REMARKS

This is intended as a full and complete response to the Office Action dated August 30, 2005, having a shortened statutory period for response set to expire on November 30, 2005. Please reconsider the claims pending in the application for reasons discussed below.

FIG. 3

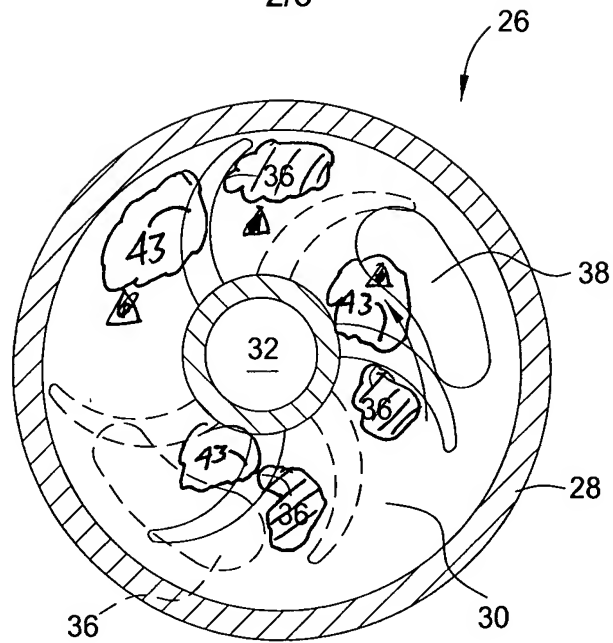
The drawings are objected to as failing to comply with 37 C.F.R. § 1.84(p)(4) because reference character "36" has been used to designate both an outlet and a vane

(see Fig.3). Figure 3 has been amended to show the vanes or blades as 43. Having corrected the drawing, Applicant respectfully requests withdrawal of the objections to the Figures.

In amended Figure 3, previously labeled element 36 has been changed to 43. In amended Figure 4 the previously omitted element numeral 98 has been added.

FIG. 2

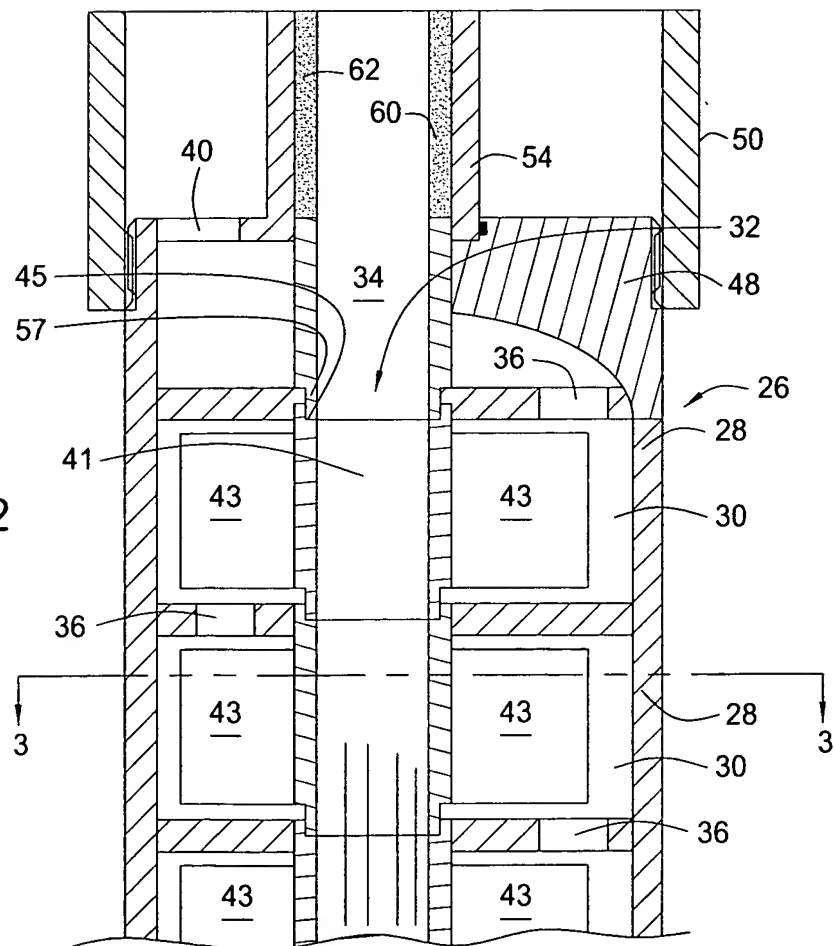
In addition, it is stated in paragraph [0021] that the uppermost outlet of the pump is sealingly engaged and in fluid communication with the inner circumference of sleeve 54. Analysis of Figure 2 leads one to believe that the outlet 40 is in communication with the annulus defined by tubing 50 and sleeve 54. It appears that if the outlet were to be in communication with the inner circumference of sleeve 54, then the system would fail because either the produced fluids would not be able to exit or the dampening capabilities would be diminished or destroyed. Applicant has corrected paragraph [0022] so that the outlet 40 is ported to the tube 50, therefore Applicant respectfully request removal of the objection.

The attached sheet of drawings includes changes to Fig. 2. This sheet, which includes Figs. 1-2, replaces the original sheet including Figs. 1-2. In Figure 2, previously omitted element 13 has been added.

FIG. 4

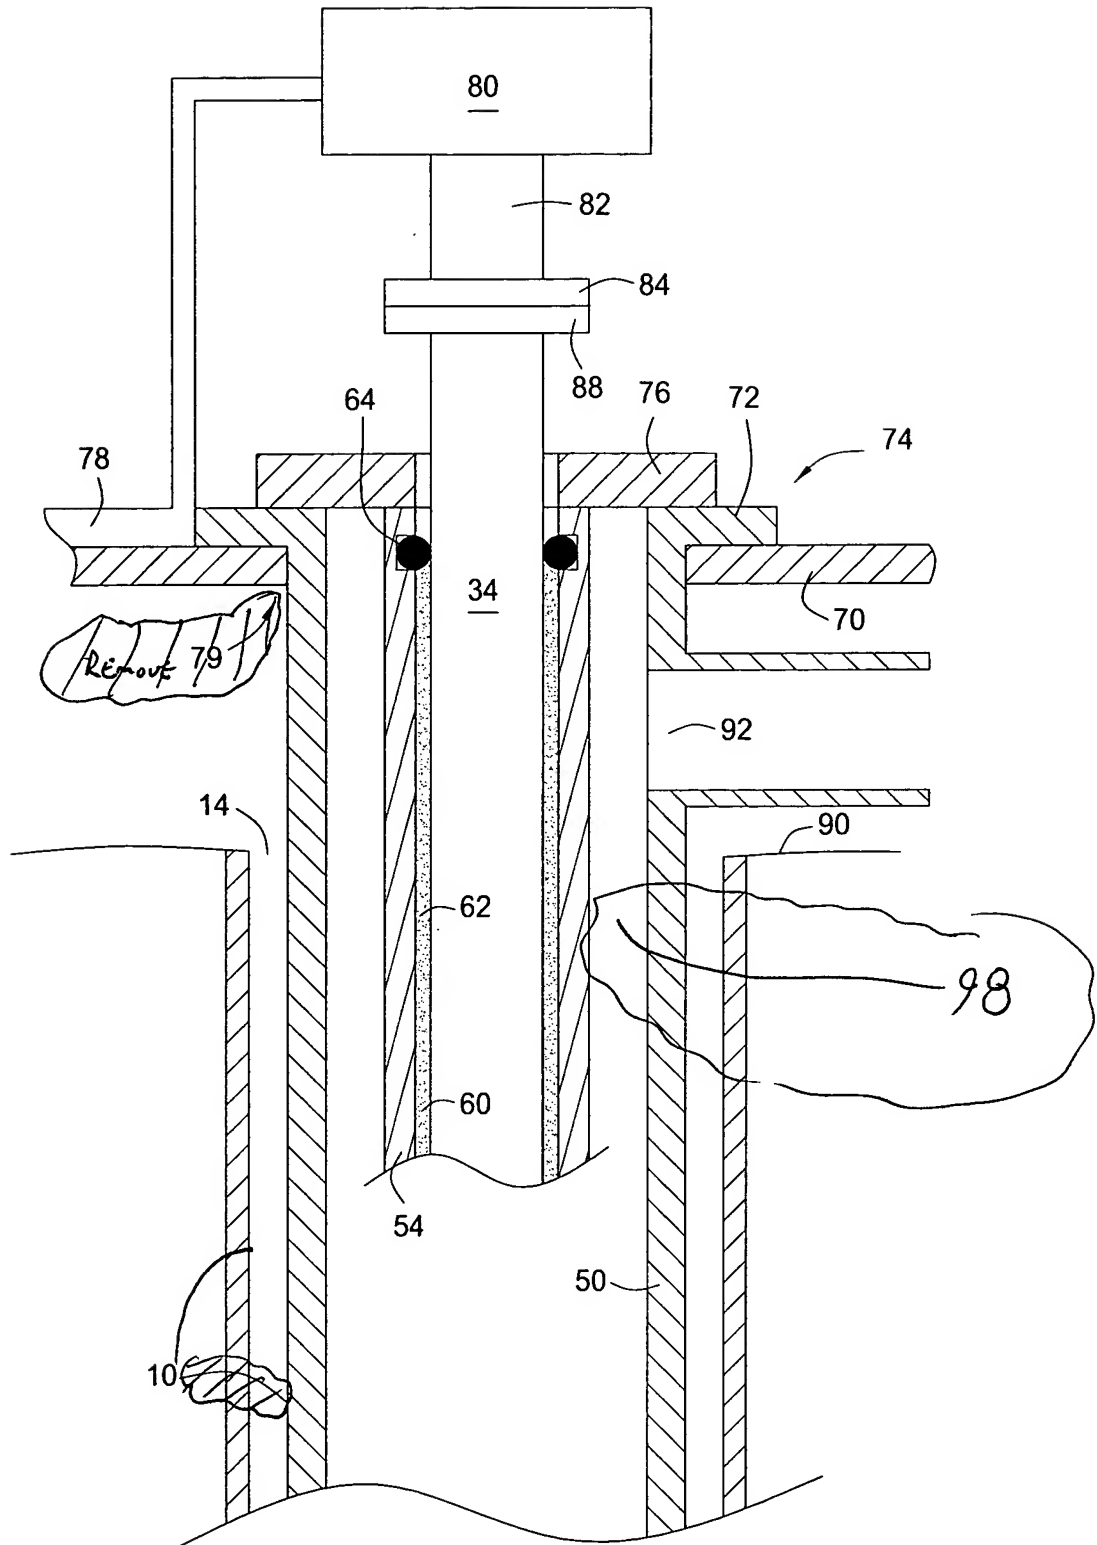
The drawings are objected to as failing to comply with 37 C.F.R. § 1.84(p)(5) because they do not include the following reference sign(s) mentioned in the description: 22, 58, and 98.

The drawings are objected to as failing to comply with 37 C.F.R. § 1.84(p)(5) because they include the following reference character(s) not mentioned in the description: 79. Applicant has removed element 79 from Figure 4.

Reference number 98 has been added to Figure 4, and 79 has been removed.
